March 3, 2010

Michael Lesar  
Chief, Rulemaking and Directives Branch  
U.S. Nuclear Regulatory Commission  
Mail Stop TWB-05-B01  
Washington, DC 20555-0001

RE: Comments on Generic Environmental Impact Statement for In-Situ Leach Uranium Milling Facilities (NUREG-1910), Docket ID NRC-2008-0420; Lost Creek SEIS, NUREG-1910 Supplement 3, Docket ID NRC-2008-0391; Moore Ranch SEIS, NUREG-1910, Supplement 1, Docket ID NRC 2009-0364; Nichols Ranch SEIS, NUREG-1910, Supplement 2, Docket ID NRC 2008-0339.

# Moore Ranch ISR Project Campbell County, Wyoming

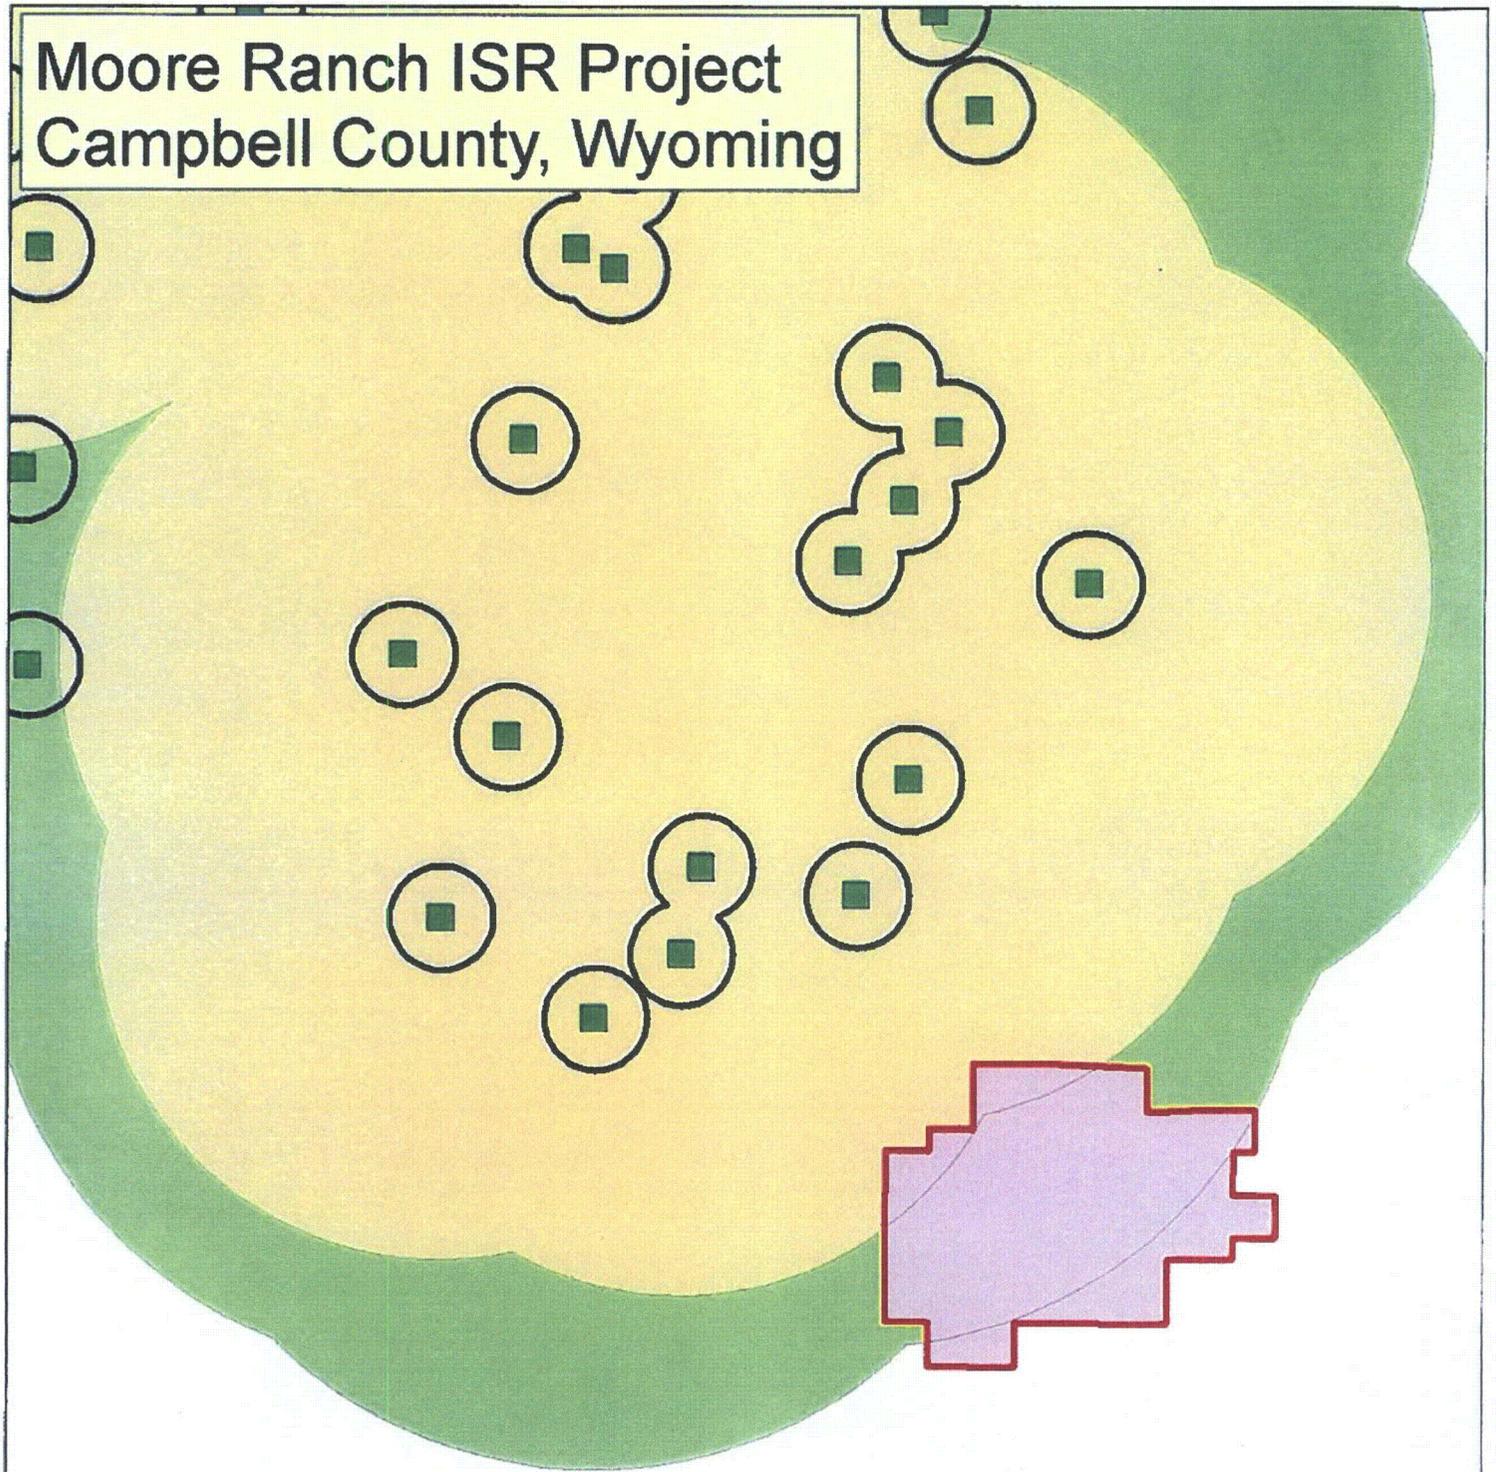
Satellite,” lies just closer than 0.6 miles from the ISR Project boundary. In total nine occupied Sage-Grouse Leaks are within five miles of the Lost Creek ISR Project Boundary. Moore Ranch ISR Project occurs within medium density and lower density Sage-Grouse breeding areas, as determined by Audubon Wyoming, and is not within Governor’s Core Areas. In total, five occupied Sage-Grouse Leaks are within five miles of the Moore Ranch ISR project boundary. Additionally, Nichols Ranch ISR Project, consisting of the Nichols Ranch Unit and Hank Unit, occurs within medium density Sage-Grouse breeding areas, as determined by Audubon Wyoming, and is not within Governor’s Core Areas. In total 20 occupied Sage-Grouse Leaks are within five miles of the Nichols Ranch ISR project boundary, including both units.
